UNITED STATES PATENT AND TRADEMARK OFFICE

APPLICATION NO.	FILING DATE	FIRST NAMED INVENTOR	ATTORNEY DOCKET NO.	CONFIRMATION NO.
10/773,076	02/05/2004	Michael Jeffery Doyle	DoYLE - rADoN	6028

Office Action Summary

DETAILED ACTION

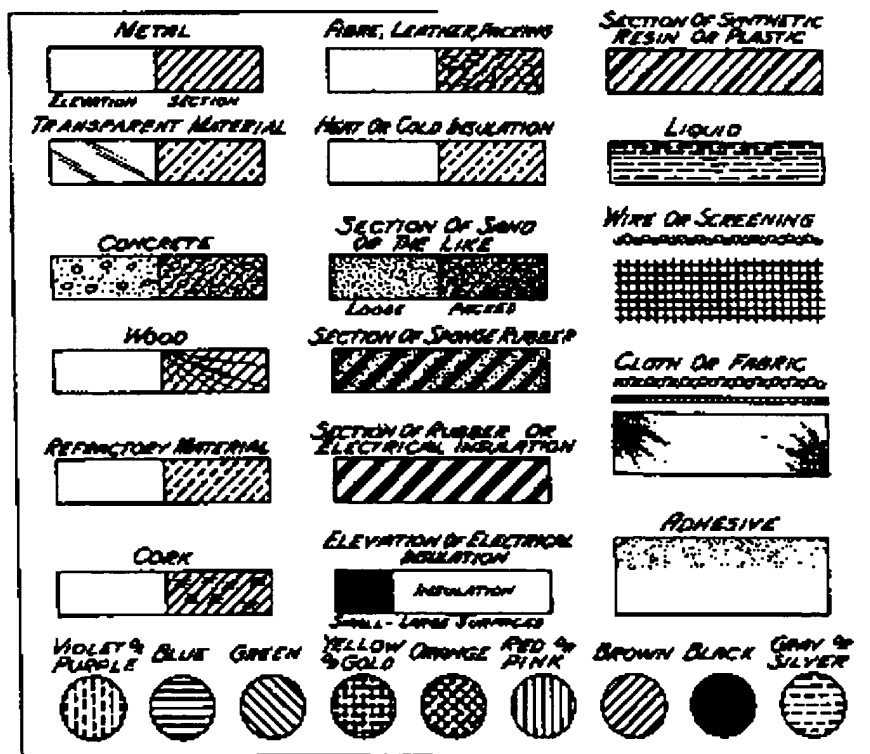
Fig. 4: Proper cross-sectional hatching is required to properly denote (1) concrete material for numeral 19 (see numeral 24 of Crawshaw (US 4,988,237) for a good example), and (2) "loose sand or the like" hatching (i.e., stone) (see below) for gas permeable material 20 in accordance with MPEP 608.02. The layers are incorrectly hatched for metal. See the drawing below for proper hatching examples.
